APPLICATION FOR MODIFICATION OF PLANNING APPROVAL
No 320110022P ~ CAR PARK - BALDERSTONE

CLIENT: Balderslee Church
 PROJECT: Amendment to approved Plans for
 Car Park application Number 3/2011/0022
 LOCATION: Land Opposite Balderslee
 School, Compton Lane, Balderslee

**Information in support of a
Request for Modification
of Planning Approval No 320110022P**

APPLICATION TO MODIFY THE PLANNING APPROVAL BY
DISPENSING WITH THE THREE GRAVEL-SURFACE ZONES
AND INSTEAD INCORPORATE THREE PLANTED AREAS

Balderstone Car Park Map Ref JP/CB/3320/B

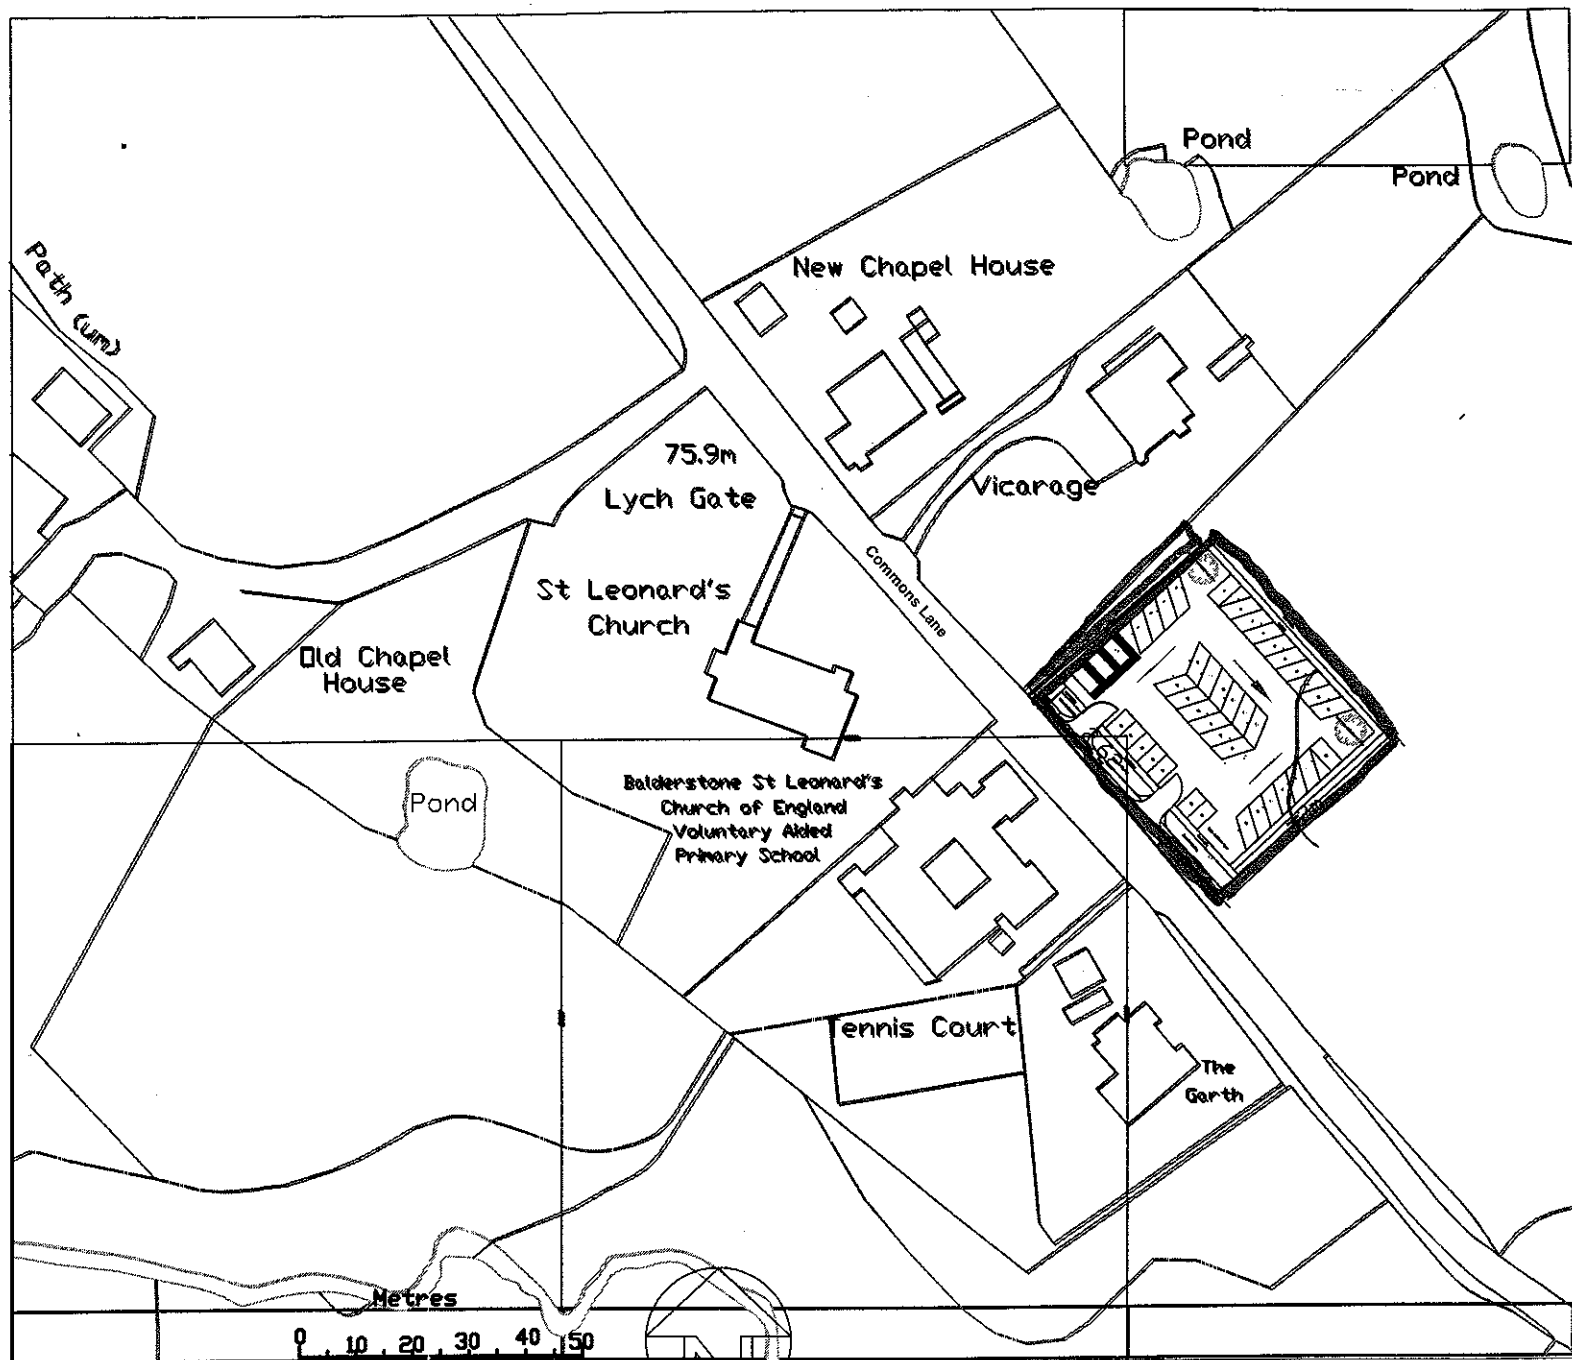
Also shrubs will be planted between the car park and the Vicarage hedge in the area marked in blue on the location drawing JP/CB/3320B.

DATE: 14th Dec 2011
 DWG NO: JP/JM/3414/1
 SCALE: 1:500

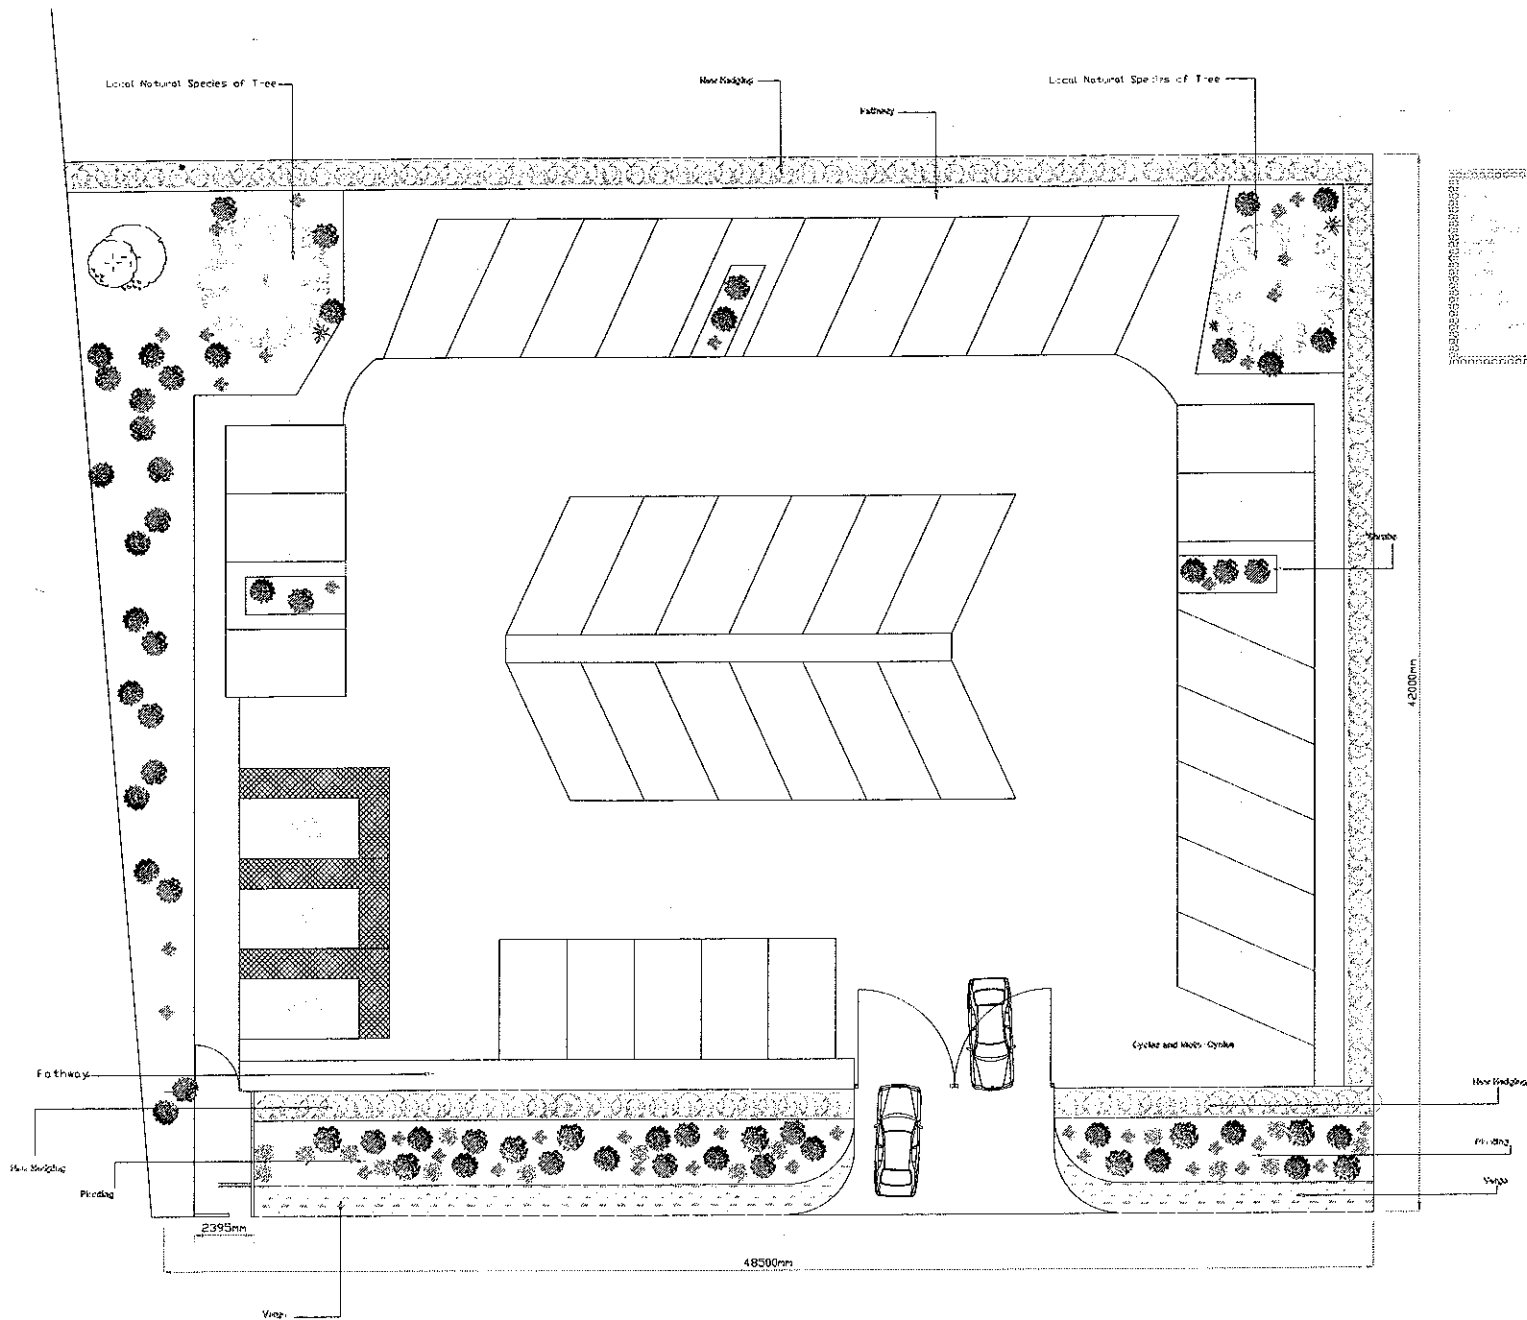
Dispense with the three gravel-surface parking areas defined in the planning approval, and in order to enhance the visual appearance:

- Incorporate three areas of shrub planting each of approximately 4 m x 1.5 m, resulting in the reduction of parking capacity by 3.

Please refer to the modified drawing Ref No JP/JM/3414/a
